STATE OF ALASKA DEPARTMENT OF TRANSPORTATION & PUBLIC FACILITIES PROPOSED MARINE PROJECT SAND POINT DOCK REPLACEMENT PROJECT #: SFHWY00006/0003194 **TIDAL DATA** MHHW $+7.23^{\circ}$ MHW+6.52MLW +1.33'MLLW 0.0

AS BUILT Drawings Project Engineer(s): Randall E Johnston & Steve Mielke **Contractor: Western Marine Construction Inc.**

Project As-Built Drawings have been reviewed by the Project Engineer and represent to the best of my knowledge the project as constructed.

SHEET TOTAL NO. SHEETS REVISION STATE PROJECT DESIGNATION YEAR SFHWY00006 2018 32 53

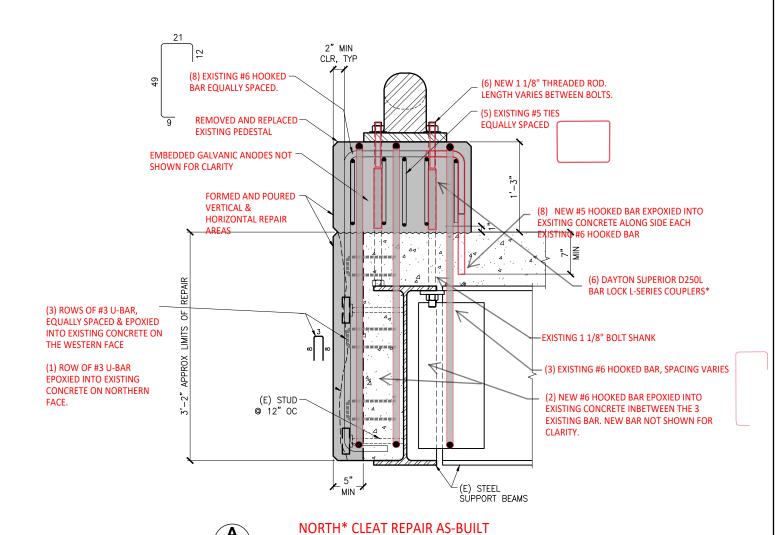
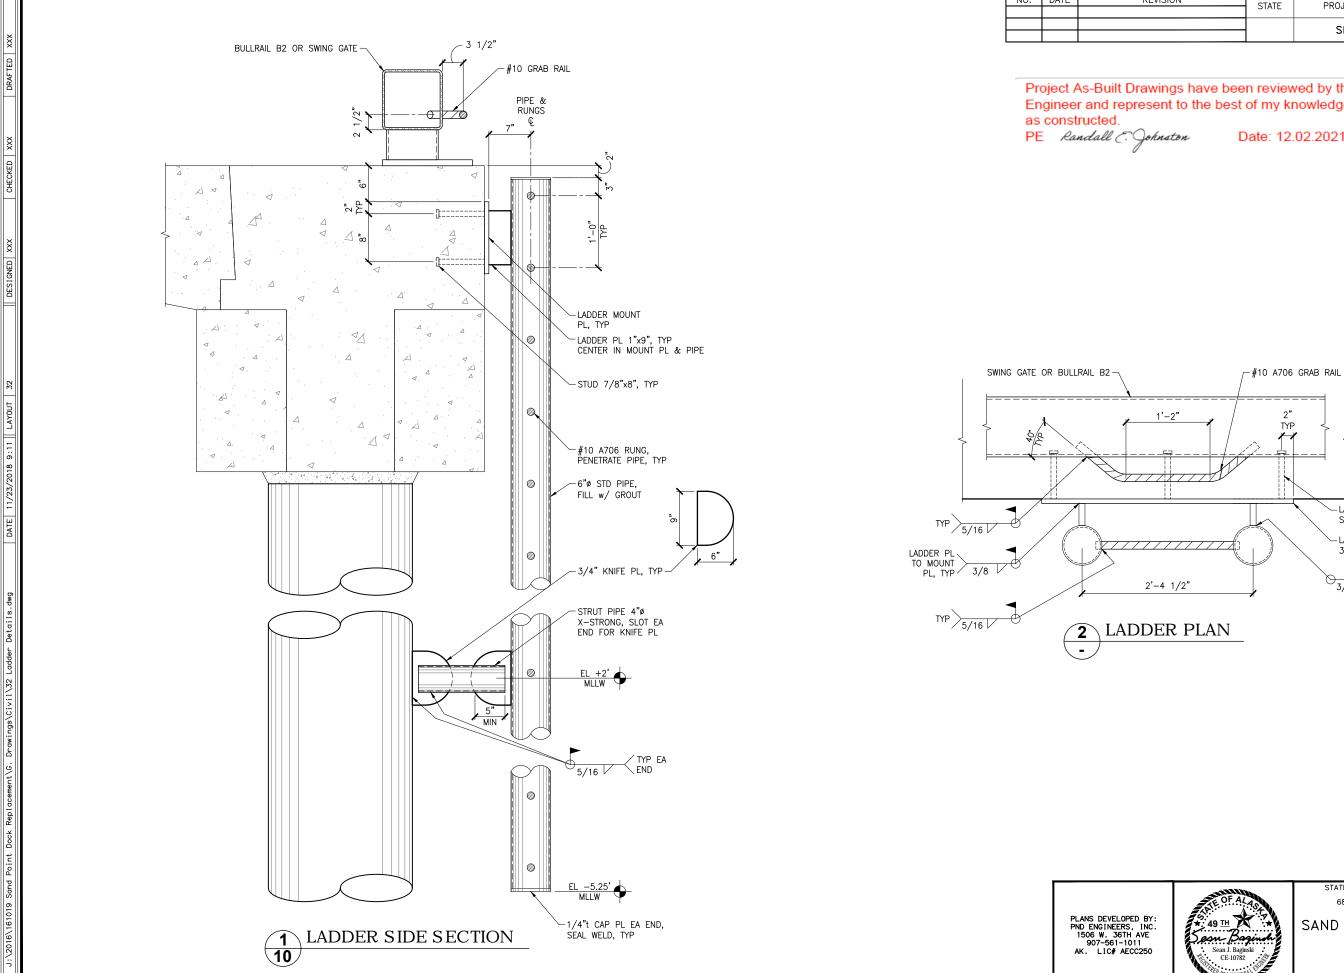
DRAWING HAS BEEN MODIFIED FROM ORGINIAL "TYPICAL REPAIR SECTION" FOUND ON SHEET 31 OF THE CONFORMED PLANS FOR SFHWY00006 SAND POINT DOCK REPLACEMENT.

ALL ALTERATIONS MADE TO DRAWING ARE APPROXIMATE AND ARE NOT TO SCALE.

SEE RFI NO. (INSERT RFI #)

*SEE SHEET 06 CLEAT LOCATION REFERENCE.

**THREADED ROD MEETING THE REQUIREMENTS OF ASTM F 1554, GR 105, GAL. - DOMESTIC.

NO.	DATE	REVISION	STATE	PROJECT DESIGNATION	YEAR	SHEET NO.	TOTAL SHEETS
			ALASKA	SFHWY00006	2018	E07	53

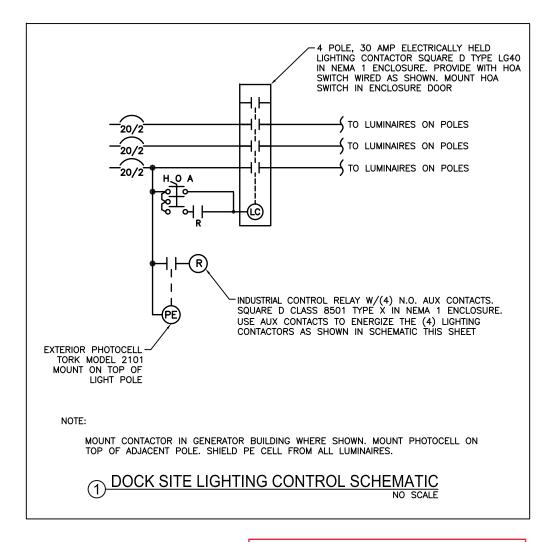
DELETED GENERATOR BUILDING AND ALL ASSOCIATED FIXTURES, PARTS, AND WIRING.

SEE CONTRACTOR PROVIDED ELECTRICAL ASBUILT DRAWINGS.

ALASKA SFHWY00006 2018 E08 53

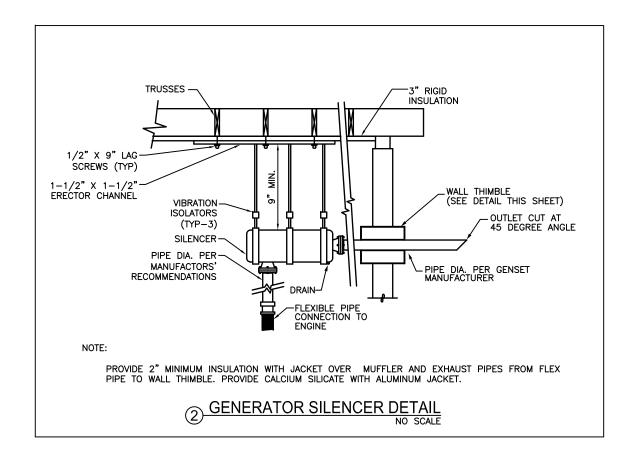
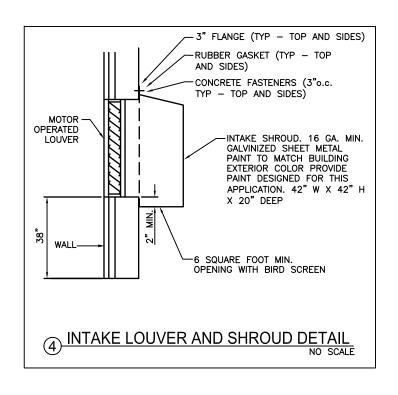
DELETED GENERATOR BUILDING AND ALL ASSOCIATED FIXTURES, PARTS, AND WIRING.
